LAND USE SERVICES DEPARTMENT ZONING ADMINISTRATOR STAFF REPORT

HEARING DATE: DECEMBER 11, 2025

APN: 0594-331-20
Applicant: Store Street LLC.
Community: Pioneertown / 3rd District
Location: 53571 Coyote Road
Project No: PVAR-2025-00051
Staff: Amy DeNinno, Contract Planner
Rep: Duane Smith
Proposal: MAJOR VARIANCE APPLICATION TO REDUCE THE SETBACK FROM A FIFTY (50') FOOT WIDE PATENT RESERVATION EASEMENT LOCATED ALONG THE INTERIOR PERIMETER OF THE SITE TO ZERO (0') FEET WHERE TWENTY FIVE (25') FEET IS TYPICALLY REQUIRED IN ORDER TO CONSTRUCT A SINGLE-FAMILY RESIDENCE, POOL, AND DECK.

MAJOR VARIANCE APPLICATION TO REDUCE THE SETBACK TO ZERO (0') FEET WHERE IT IS TYPICALLY TWENTY-FIVE (25') FEET FROM THE EDGE OF A FIFTY (50') FOOT PATENT RESERVATION EASEMENT LOCATED ALONG THE INTERIOR PERIMETER TO CONSTRUCT A SINGLE-FAMILY RESIDENCE (SFR), POOL, AND DECK, ON A 4.98-ACRE PARCEL, LOCATED AT 53571 COYOTE ROAD, PIONEERTOWN, CA 92268, IN THE RESOURCE/LAND MANAGEMENT (RLM) LAND USE CATEGORY AND RESOURCE CONSERVATION (RC) ZONING DISTRICT; 3RD SUPERVISORIAL DISTRICT; APN 0594-331-20.

SITE PLAN

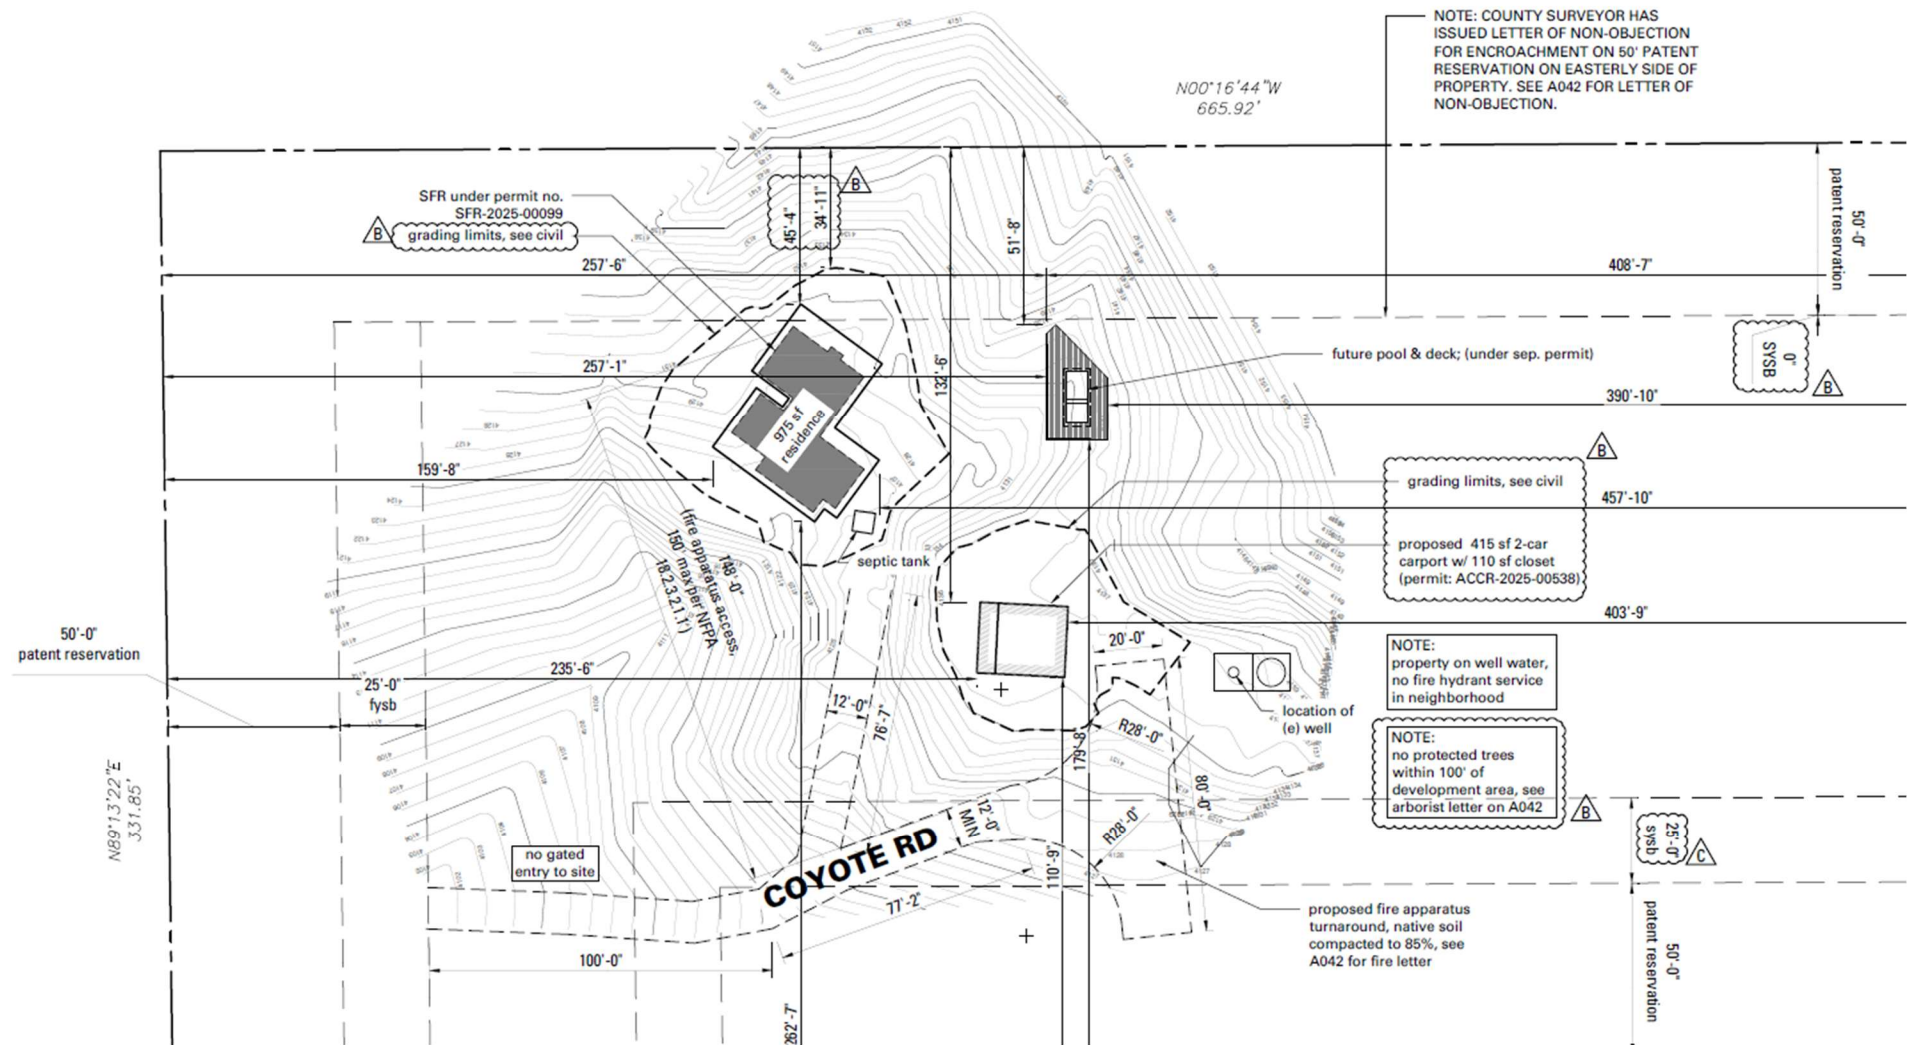
So why not just vacate the entire easement so that the setback is measured from the property line, thereby eliminating the need for the variance? No variance no required findings. While there is some topography and rocks, I do not believe it reaches the level of a hardship given the limited size of the structure on a 4 plus acre parcel. At this point it seems like a self imposed hardship. Vacating the easement seems like the path of least resistance. The non obstruction letter even mentions vacating it.

I have read the Variance Project Notice and reviewed site plan and have questions. First, why is building within a patent reservation easement which is for road/ access considered an encroachment and variance item? Variances are a means of providing relief from development standards. Building in potential future RofW is just not permitted. I see a letter of Non-Objection was provided back in May of this year. Within the letter it states that it strongly advises the application to apply for a vacation

of the patent reservation. This would appear the appropriate course of action and not a part of a variance application. Secondly, the Variance notice states that a 100% encroachment into the easterly setback is being requested. I believe this is a bit lacking on detail. I'm guessing if more detail was provided it might read something like this if I understand the Dev Code: encroaching 25 feet into the required 25' street side setback as measure from the access easement. But given the significance of the encroachment and Director review, the notice should inform the public how they can go about obtaining a staff report? Personally, I would like to read the findings justifying this request. It is hard to believe that a structure less than 1,000 sf can't be fit on a 4.5 acre parcel without encroaching into the street side yard setback. I'm familiar with the general area, so I understand the rock outcroppings and some topo issues, but it still goes back to why given the structure size verses lot size. If anything, it seems like a self-imposed hardship??

I would first like to say that reviewing the variance description against site/grading plan does not appear to match. On sheet A100, I see that along the easterly side of the property, the limits of grading would be 34'-11" away from the property line, and the structure would be 45'-4" from the property line. This equates to an approximately 15-foot encroachment of the grading into the 50-foot easement and the structure encroaching 4'-6" into the easement. Based on a 25-foot building setback as measured from the edge of the easement, the encroachment of the structure goes beyond an encroachment into a required setback. I would further add that it appears the future pool encroaches as well. This would seem to make the public notice inaccurate.

Quick clarifying response to your comments below. The proposed structure will still be contained entirely within the applicant's property and will not be encroaching onto another parcel.

The patent reservation easement is a 50 foot reservation BLM granted to the County that is contained entirely within the boundaries of the applicant's lot. Additionally, as part of the review for this project, the County determined there is no planned road in the portion of the reservation easement that the applicant is proposing an encroachment into. I am including a snapshot below – the red circle indicates where the encroachment is occurring. The proposed structure will be 45 feet and 4 inches from the nearest property line.

The 50 foot reservation was granted to the County by BLM and is contained entirely within the boundaries of the applicant's lot. Additionally, as part of the review for this project, the County determined there is no planned road in the portion of the easement that the applicant is proposing an encroachment into. I am including a snapshot below as well – the red circle indicated where the encroachment is occurring. The proposed structure will be 45 feet and 4 inches from the nearest property line.
